BP Cherry Point Cogen
DEIS Comment - 18

SUBJECT: Comments on BP Cherry Point Cogeneration Project Draft Environmental Impact Statement DOE/EIS-0349

RE: BP Cherry Point Cogeneration Project DEIS

Figure 1. Annualized costs for a 540 MW natural gas CCCT

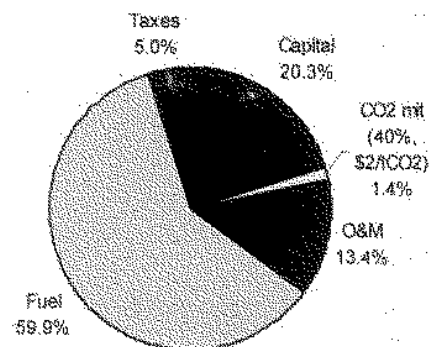
Figure 1 shows how this 0.06c/kWh offset cost compares with other cost components of a new natural gas plant. Not surprisingly, fuel costs are predominant, and are also highly uncertain, especially in light of price surges and concerns echoed by Federal Reserve chairman Alan Greenspan. If instead of the NPPC's medium gas forecast shown here (\$3.70/MBtu levelized 2005–24), their high estimate were realized (\$4.56/MBtu, levelized), the cost of electricity production would rise by 0.60 c/kWh, roughly ten times the magnitude of the offset cost imposed under a 40%/\$2 mitigation requirement.
